Version 2 of the Reliable Data Protocol (RDP)

This RFC suggests several updates to the specification of the Reliable Data Protocol (RDP) in [RFC-908](#) based on experience with the protocol. This revised version of the protocol is experimental.

RDP Header Format
Figure 1

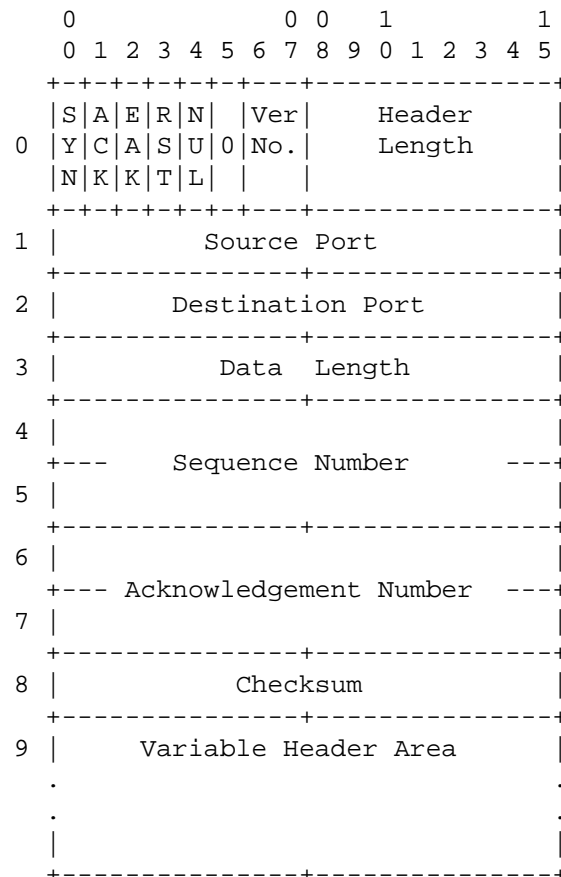
There are three changes to the protocol header: the checksum algorithm has been changed, the port size increased, and the version number incremented. The new header format is shown in Figure 1.

The major discovery during the testing of the protocol is that cost of computing the the RDP checksum proved surprisingly variable; its performance was more heavily affected by the host's data representation than anticipated. Optimized checksum implementations on two comparable hardware bases gave performance that differed by a factor of five. Since the speed of the checksum is a key factor in the performance of the protocol itself, this variation caused a noticeable difference in throughput.

The wide variation in performance on comparable machines was felt to be undesirable, so the checksum has been changed. RDP now uses the 16-bit TCP checksum, which is specified on page 16 of [RFC-793](#).

The 8-bit port size is probably too small to support a large range of applications. Accordingly, the port size is now 16-bits. Port numbers less than 1024 are reserved for well-defined applications. Allocable ports begin at port number 1024.

Finally, because the checksum and port size have been changed, the version number has been increased to 2.
